**DEXUS QUARRYWEST PROJECT (SSD 6801) – SECTION 4.55 MODIFICATION (MOD 8) –
RESPONSE TO SUBMISSIONS**

FIRE ENGINEERING STATEMENT

**DEXUS QUARRY WEST LOT E– SSD 6801 MOD 8 - WAREHOUSE E3 AND E4, PROSPECT HIGHWAY
PEMULWUY**

Figure 1: Indicative pathway around conveyor location

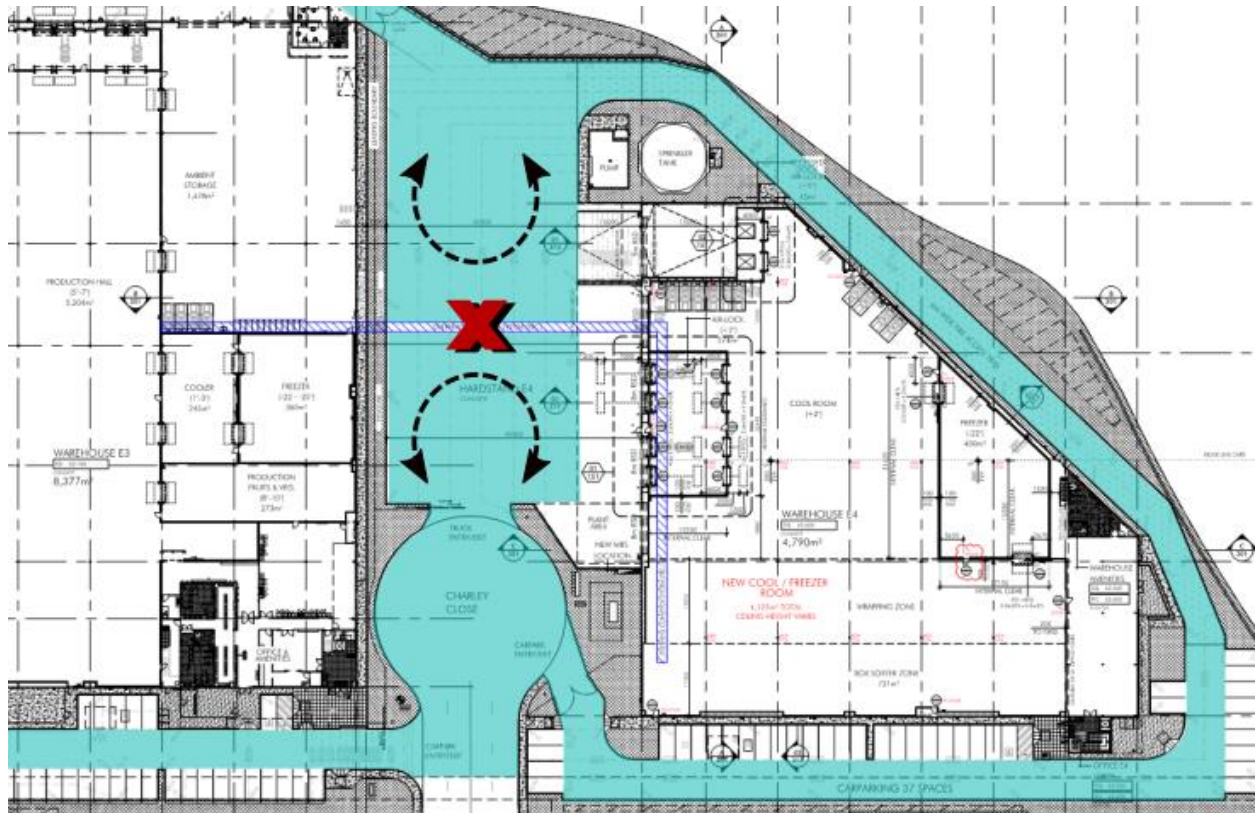
- 1. Consideration be given to the impact that the new conveyor structure including supporting columns will have on the requirements for emergency vehicle access between the warehouses.***

Whilst the conveyor passes over the roadway currently relied upon for access to Warehouse E3 and E4 a Performance Solution can demonstrate compliance with CP9 subject to consultation with FRNSW during design development. The fire safety strategy will rely upon:

- The conveyor structure is independent to that of the warehouses, with physical protection provided to the columns to protect them from impact damage; and
- There is redundancy in the design as alternative pathways that circumnavigate the remainder of the building are available (refer to the shaded area in **Figure 1**); and

- The clear height to the underside of the conveyor exceeds the 4.5 m required under Clause 5.5 of FRNSW's Policy No.4 (Guidelines for Emergency Vehicle Access); and
- If Warehouse E3 and Warehouse E4 were to be considered as a united building under the BCA there is no DTS non-conformance.
